Subject: POWER LIFTGATE CLOSSES BUT DOES NOT LATCH COMPLETELY	Bulletin No: 09-017/13
	Last Issued: 05/28/2013

2007-2013 CX-9 vehicles with VINs lower than JM3 TB ***** 418826 (produced before April 4, 2013)

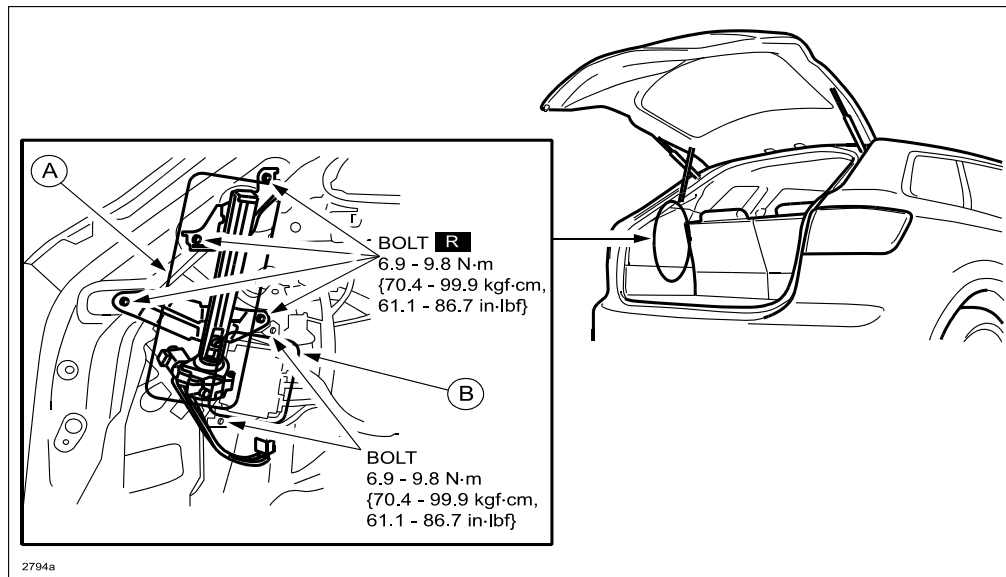
Some customers may experience a power liftgate (PLG) that closes but does not latch completely when the PLG button is pressed.

Replace the PLG driver, PLG slider and PLG control module.

1. Verify customer concern.
2. Disconnect the negative battery cable.
3. Replace the PLG driver and PLG slider (A). Refer to MS3 online or Workshop Manual:
 - PLG driver - section 09-11 POWER LIFTGATE (PLG) DRIVE UNIT REMOVAL/INSTALLATION
 - PLG slider - section 09-11 POWER LIFTGATE (PLG) SLIDER REMOVAL/INSTALLATION

NOTE: Install with 4 new bolts and torque them to 61.1 - 86.7 in-lbf (70.4 - 99.9 kgf-cm).

4. Replace the PLG control module (B). Refer to MS3 online or Workshop Manual (section 09-11 POWER LIFTGATE (PLG) CONTROL MODULE REMOVAL/INSTALLATION).

NOTE: Install with 2 new bolts and torque them to 61.1 - 86.7 in-lbf (70.4 - 99.9 kgf-cm).
